Access Compliance Report

Public Rights-of-Way

(Curb Ramps)

Intersection ID: 6068	Main Street: CATHEY_RD	Cross Street: COULWOOD_DR	Location: S
ADA ID: 3D8FAE1A6A29	Ramp Type: Perp	Initial Pass/Fail: Fail	Overall Compliance: No
Codes/Mitigation Info/Possible Solution		Field Measurements/Component Compliance	
Severity Score: 33.75

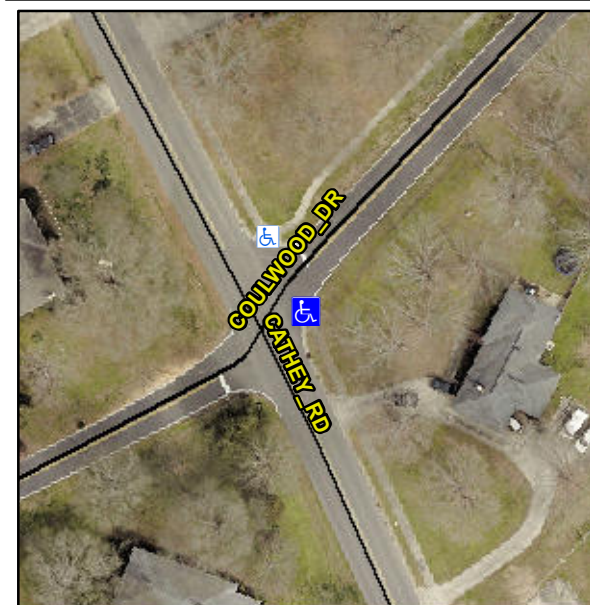
Not Found, R304.5.1, R304.2.2, R304.5.3

Compliance	Description	Data	Compliance	Description	Data
N/A	Ramp Length (in)	48.5	No	Ramp Slope (%)	8.6
No	Ramp Width (in)	40.5	No	Ramp XSlope (%)	5.5
N/A	Flare Type LT	N/A	N/A	Flare Type RT	N/A
N/A	Flare Slope LT (%)	N/A	N/A	Flare Slope RT (%)	N/A
N/A	Flare Traversable LT?	N/A	N/A	Flare Traversable RT?	N/A
N/A	Landing Length (in)	N/A	N/A	DWS Provided?	N/A
N/A	Landing Width (in)	N/A	N/A	DWS Contrast?	N/A
N/A	Landing Slope (%)	N/A	N/A	DWS Length (in)	N/A
N/A	Landing X Slope (%)	N/A	N/A	DWS Full Width?	N/A
N/A	Landing Curb? (Y/N)	N/A	N/A	DWS Offset (in)	N/A
N/A	Shared Landing?	N/A			
N/A	Gutter Ponding?	N/A	N/A	Gutter Slope (%)	N/A
N/A	Gutter Lip Ht (in)	N/A	N/A	Gutter X Slope (%)	N/A
N/A	Painted X Walk1?	No	N/A	Painted X Walk2?	N/A
	X Walk 1 Direction	To N		X Walk 2 Direction	N/A
N/A	X Walk 1 Width (in)	N/A	N/A	X Walk 2 Width (in)	N/A
	X Walk 1 Slope (%)	0.7		X Walk 2 Slope (%)	N/A
	X Walk 1 X Slope (%)	3.2		X Walk 2 X Slope (%)	N/A

Remove & Replace Entire Ramp.
